SERVICE BULLETIN

M-1079

Safety Recall Code 095

ENGINE CAM SPROCKET BOLT REPLACEMENT

Figure 1. Lock Crank and Primary Cam Sprockets

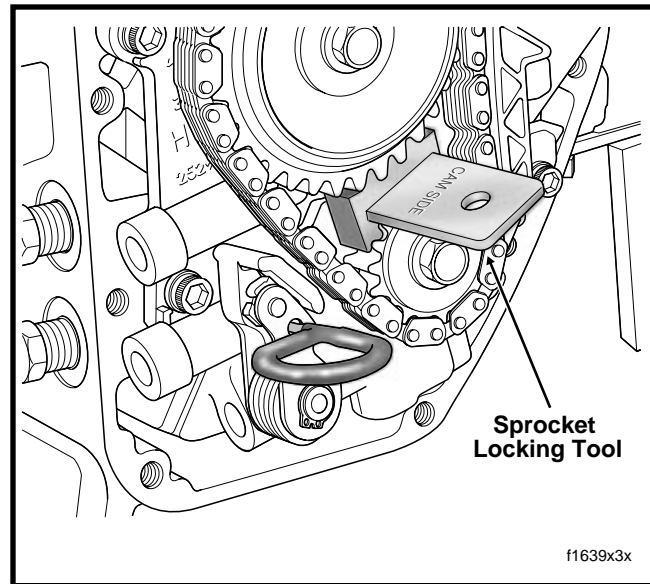
1. Position the CRANKSHAFT/CAMSHAFT SPROCKET LOCKING TOOL (HD-42314) between the crank and primary cam sprockets to prevent rotation. The handle of the tool is stamped "Crank" and "Cam" to ensure proper orientation. See Figure 1.

Figure 2. Flange Bolts and Flat Washers

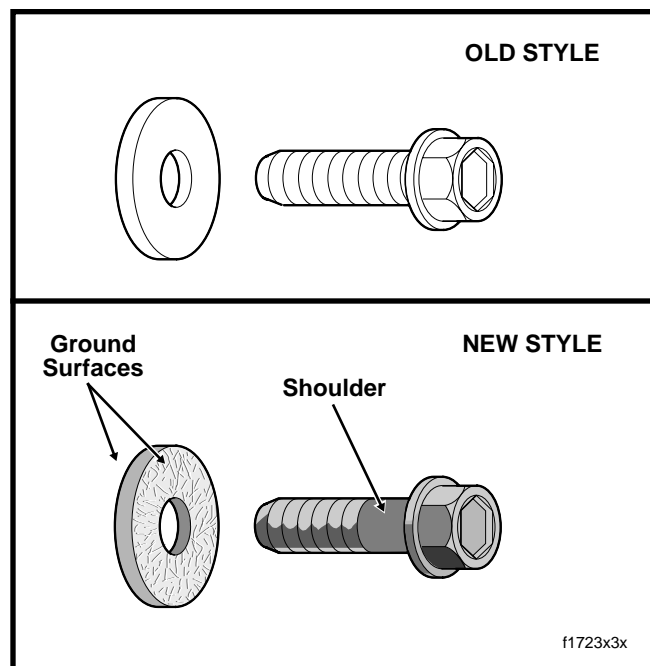
2. Remove the flange bolts and flat washers from the crank and primary cam sprockets. Discard both the bolts and flat washers.

See Figure 2. New crank and primary cam sprocket flange bolts are shouldered while the new flat washers have ground surfaces. The new flange bolts and flat washers are interchangeable.

3. Install **new** crank and primary cam sprocket flange bolts and flat washers as follows:

- a. Hand thread flange bolt (with flat washer) into end of camshaft. The bolt should easily thread completely into hole by hand. Remove bolt, and if necessary, run a 5/16" - 18 tap into hole to clean out any residual threadlocker.

- b. Hand thread flange bolt (with flat washer) into end of crankshaft. Again, the bolt should easily thread completely into hole by hand. Remove bolt, and if necessary, run a 5/16" - 18 tap into hole to clean out any residual threadlocker.

- c. Verify that all threads are free of oil and debris.
 - d. Apply Loctite Primer 7649 (P/N 98968-99) to threads of flange bolts.
 - e. Apply one drop of Loctite High Strength Threadlocker 262 (red) to threads of flange bolts.

- f. Apply a thin film of clean H-D 20W50 engine oil to both sides of flat washers.
 - g. Install flange bolt with flat washer into end of crankshaft. Exercise caution to avoid mixing oil on washer with threadlocker on bolt.

- h. Install flange bolt with flat washer into end of camshaft. Exercise caution to avoid mixing oil on washer with threadlocker on bolt.
 - i. Alternately tighten the crank and primary cam sprocket flange bolts to 15 ft-lbs (20.3 Nm).

- j. Loosen each flange bolt one full turn.
 - k. Alternately tighten the crank and primary cam sprocket flange bolts to 24 ft-lbs (32.5 Nm).
 - l. Remove the sprocket locking tool.

Figure 3. Cam Cover Torque Sequence

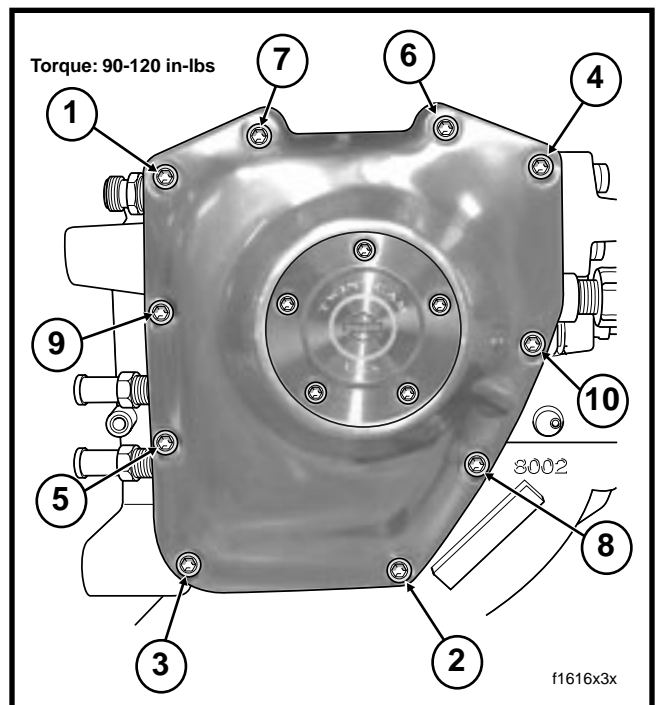
1. Align holes in **new** cam cover gasket with those in the crankcase flange.
2. Install the cam cover using ten allen head socket screws. Following the pattern shown in Figure 3, alternately tighten screws to 90-120 **in-lbs** (10.2-13.6 Nm).
3. Capturing engine sensor harness conduit in cable clip, start T20 TORX screw into threaded hole at front of crankcase. Tighten screw to 20-30 **in-lbs** (2.3-3.4 Nm).
